## ADDENDUM #1

**PROJECT:** Woodbury Avenue Signal Interconnect  
NHDOT Project No. 29781  
Federal Aid Project No. X-A004(304)  
City Project No. 22002

**DATE:** May 19, 2017

**RE:** Granite St Luminaire & MA Rotation

PROJECT:	WOODBURY AVENUE TRAFFIC SIGNAL INTERCONNECT	PROJECT NO.:	T0543
LOCATION:	PORTSMOUTH, NEW HAMPSHIRE	DATE:	05/19/2017
TITLE:	ADDENDUM #1: GRANITE ST LUMINAIRE & MA ROTATION	SCALE:	1" = 30'

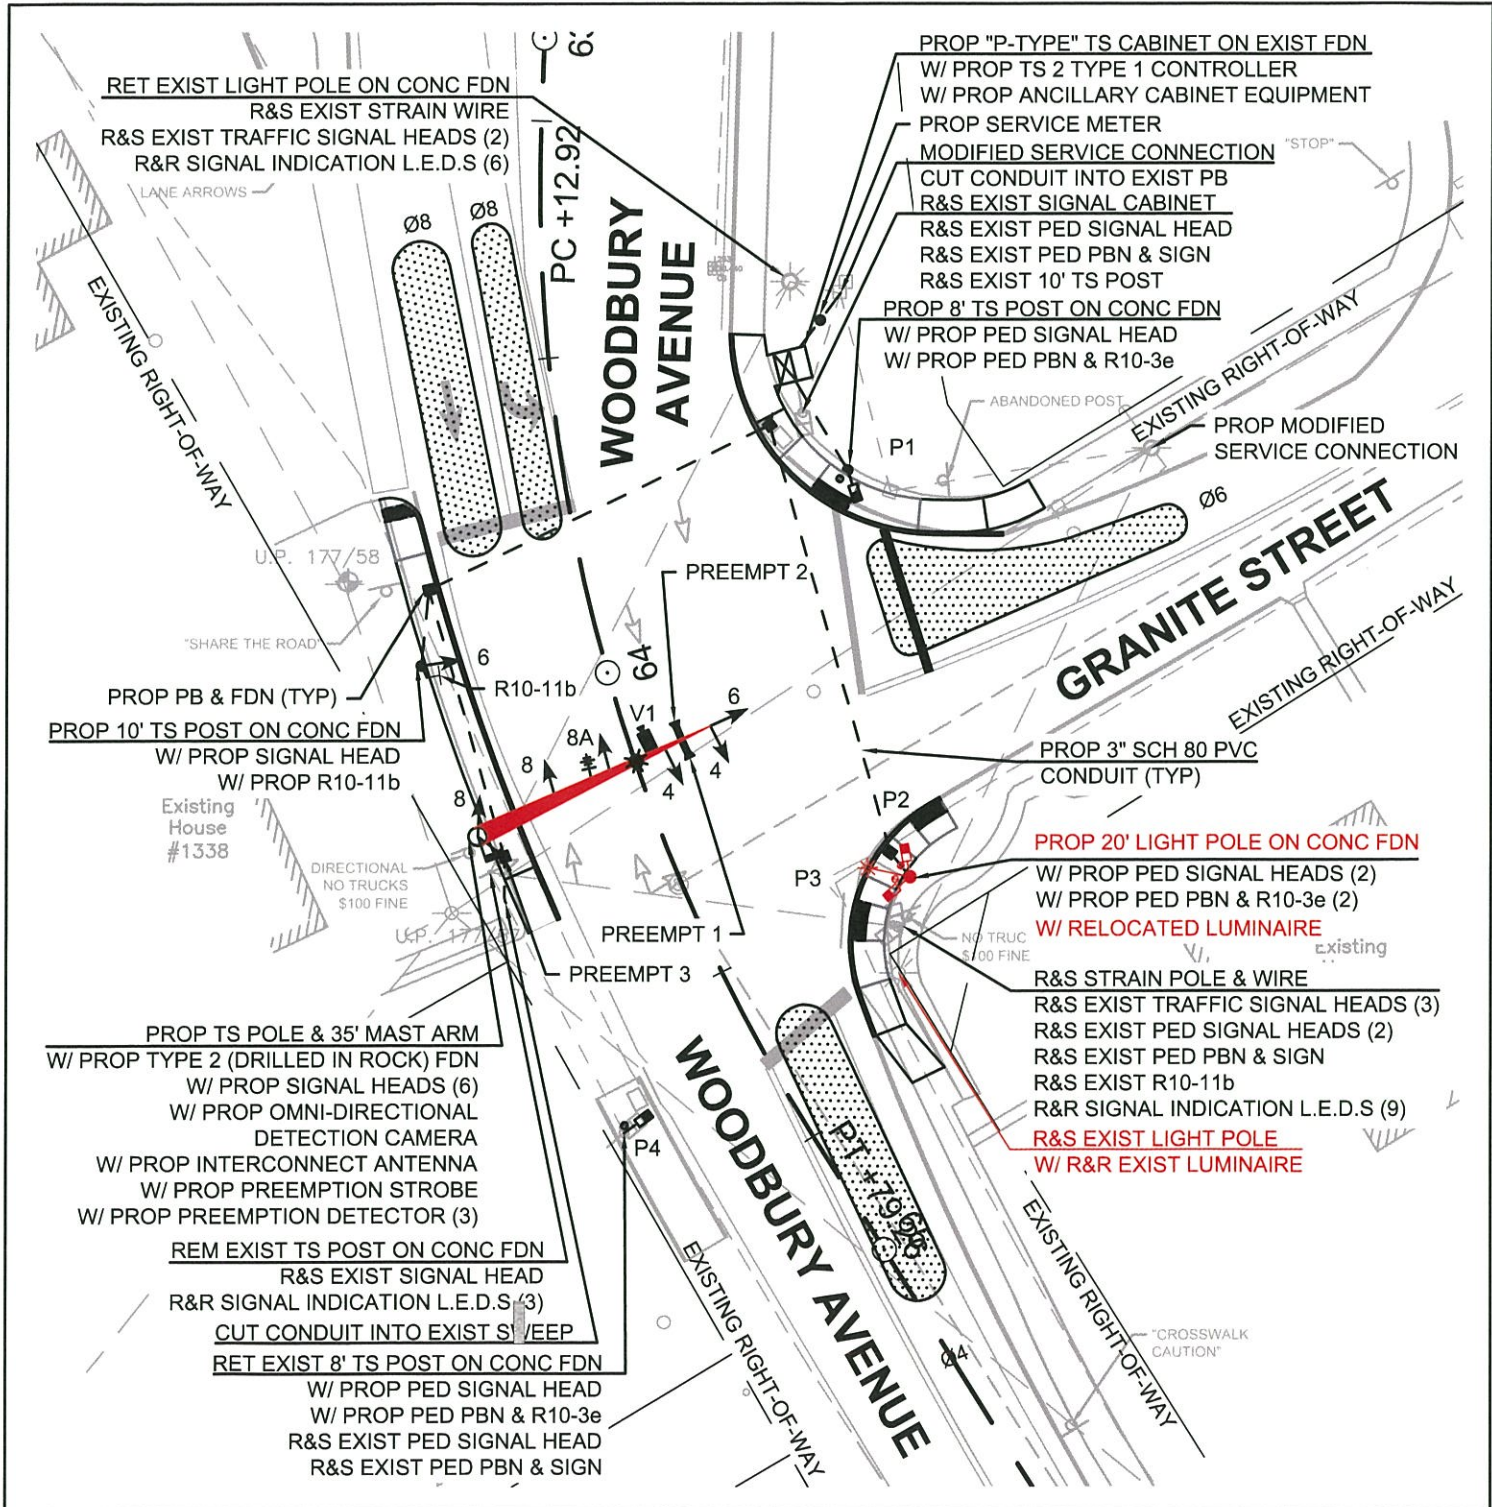
**Item No. 1** - *Woodbury Avenue at Granite Street* – The Bidder/Contractor shall furnish new and/or remove existing items at the intersection of Woodbury Avenue at Granite Street as originally shown on PS&E Design Plans dated April 17, 2017. The modifications are depicted on attached Addendum #1 Plan (8.5"x11") and include:

- Part of Item 616.196 (U) - Rotate "PROP TS POLE & 35' MAST ARM" at STA 64+17 RT 27'
- Part of Item 616.196 (U) – Remove part of item "PROP 8' TS POST ON CONC FDN" at STA 64+49 LT 33' from plans in lieu of proposed light pole (LP)
  - TS equipment will be retained on proposed LP
- Item 625.52 – Add "PROP 20' LP ON CONC FDN" at STA 64+50 LT 33'
- Item 625.621 – Remove and Reset "LUMINAIRE" to STA 64+50 LT 33'
- Item 625.622 – Remove and Stack "EXIST LP" at STA 64+63 LT 24'
